Service Bulletin No: 55-004

STABILIZERS - HORIZONTAL STABILIZER - CHECK OF THE REAR ATTACHMENT BOLTS**1. Planning Information****A. Effectivity**

Rear Attachment Bolt - Component Location
Figure 1

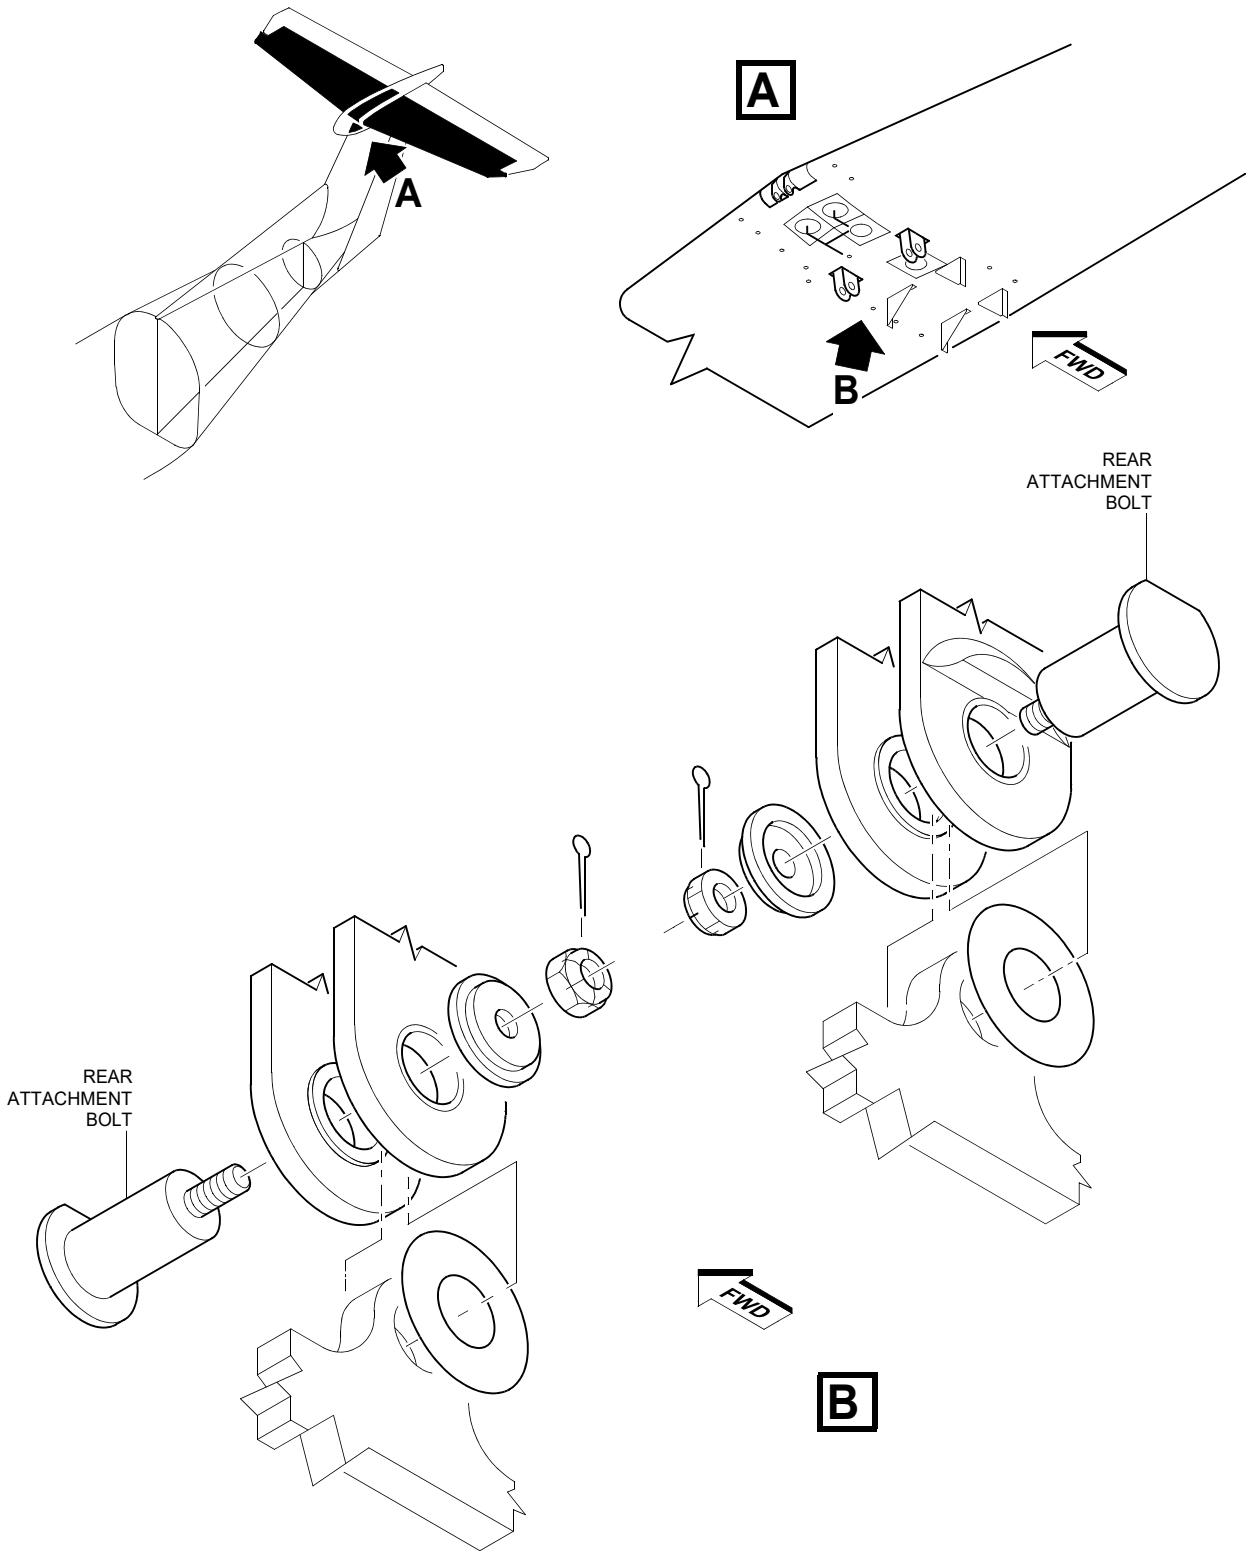
Horizontal stabilizer rear attachment bolts P/N 555.10.12.139 with FAUF 10169753, FAUF 10171067 or FAUF 10171267 without the correct heat treatment have reduced material properties, which can possibly result in fatigue failure.

At the 12 Months Inspection interval, do a check of the part number and production order number of the rear attachment bolts for the horizontal stabilizer. Replace the bolts if necessary.

Refer to Figure 1 and Figure 2.

- (1) Check the rear attachment bolts to determine the P/N and FAUF.
- (2) Replace the rear attachment bolts, refer to AMM 55-10-01-00A-920A-A, and return the bolts to Pilatus, if one of these conditions apply:
 - (a) The P/N and FAUF are listed in 1.C.(1)
or
 - (b) The bolts were installed between July 24, 2018 and the issue date of this Service Bulletin, but the P/N and FAUF are not readable.
- (3) If the rear attachment bolt(s) was replaced, do the adjustment/test of the horizontal stabilizer trim, refer to AMM 27-40-00-00A-903A-A.
- (4) If the rear attachment bolt(s) was replaced, do the adjustment/test of the airfoil de-ice system. For PC-12, PC-12/45, PC-12/47 Series aircraft refer to AMM 30-10-00-00A-903A-A. For PC-12/47E Series aircraft, refer to 30-10-00-00A-903A-A or 30-10-00-00A-903B-A.
